To be held on Monday, May 26, 2014 at **2:00 p.m.** Committee Members are asked to meet in the **Council Chambers** at 395 Mulock Drive, Newmarket, Ontario.

1. REQUEST FOR EXEMPTION FROM SITE PLAN APPROVAL p. 1
380 BAYVIEW AVENUE - WARD 3
(WEST SIDE OF BAYVIEW PARKWAY, NORTH OF ELGIN STREET)
(OWNER: THE REGIONAL MUNICIPALITY OF YORK)

2. APPLICATION FOR SITE PLAN APPROVAL p. 16
17150 YONGE STREET - WARD 7
(NORTH SIDE OF EAGLE STREET, WEST SIDE OF YONGE STREET)
OUR FILE NO.: D11-NP1403
THE REGIONAL MUNICIPALITY OF YORK

SITE PLAN REVIEW – 17150 YONGE STREET

DESIGN M.B.	NEWMARKET SEWAGE PUMPING STATION UPGRADES MINISUB GENERAL ARRANGEMENT AND SINGLE LINE	DWG. NO. E-109
DRAWN B.M.		CONT. NO. T-13-58
CHECKED M.B.		SHEET NO. 58

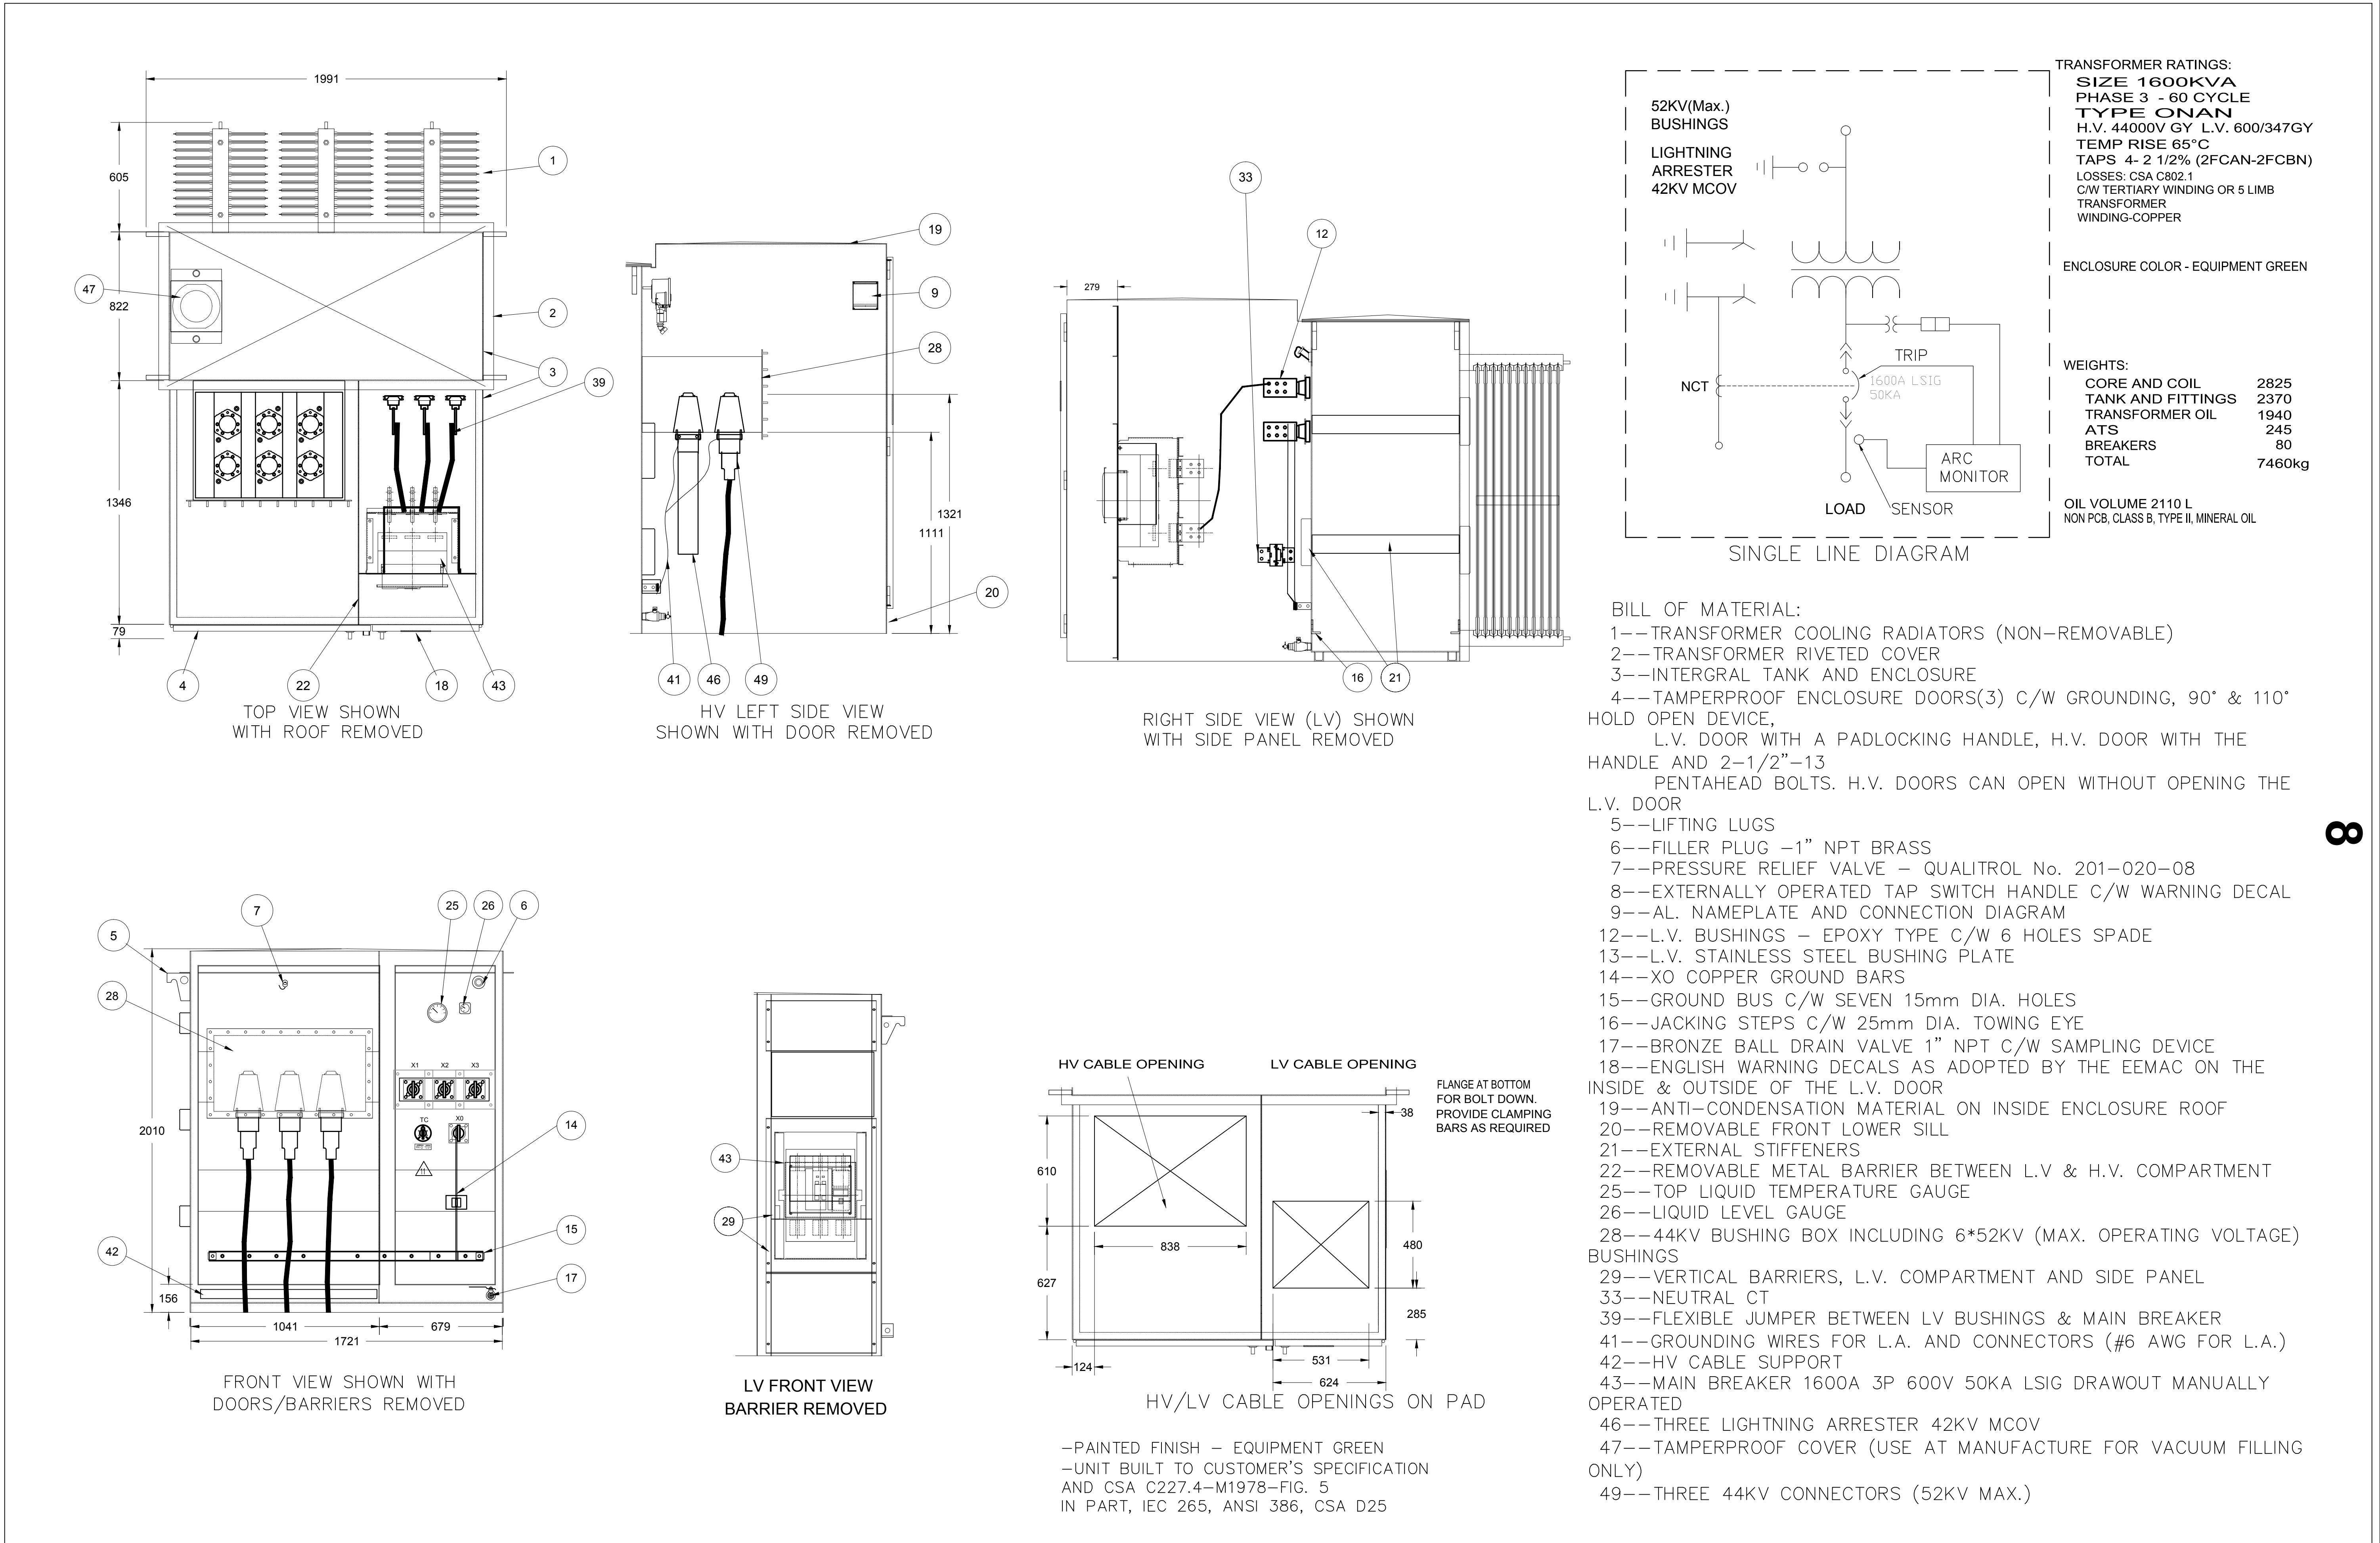
The existing substation will be replaced with an electrical mini-substation in the same location. The proposed substation is smaller than the existing substation and will be installed on a concrete pad on-grade behind the existing barrier wall. Please refer to attached drawing *E-109* for the layout and dimensions of the proposed mini-substation. It is expected that the reduced footprint will improve the overall visual impact of the substation to the surrounding neighborhood.

SP-1

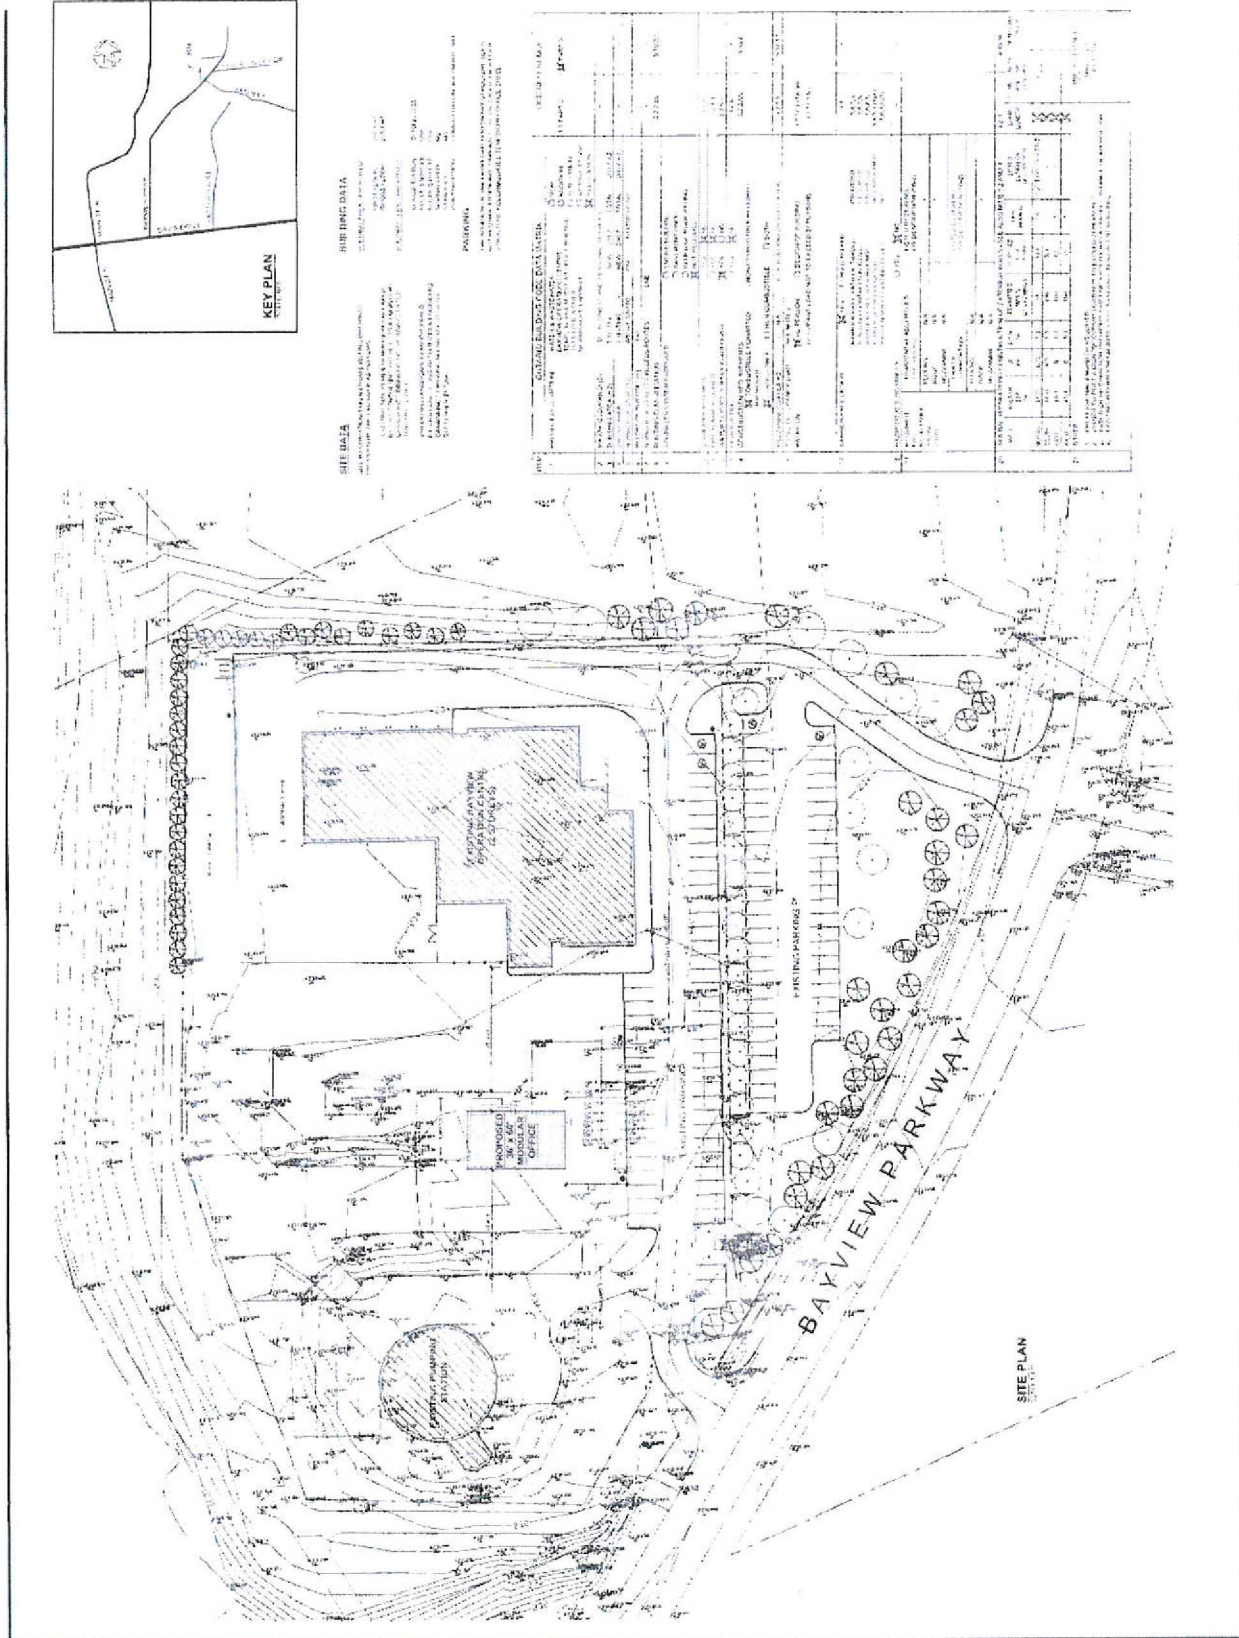
The temporary unit supplied by Modspace, will be 36 feet deep by 60 feet wide, and will be located 86 feet from the south side of the main building (see attached Site Plan SP-1). The unit will be 3 feet 2 inches max from grade to finished floor, and 9 feet 1 inch from finished floor to the underside of the roof joist. The temporary unit will be installed on a granular pad, with wood siding for exterior cladding, Smart Panel fascia and trim, vinyl windows, and Polyvinyl Chloride roofing. Electrical will be run from the main building to the unit, and the unit will have no plumbing or water.
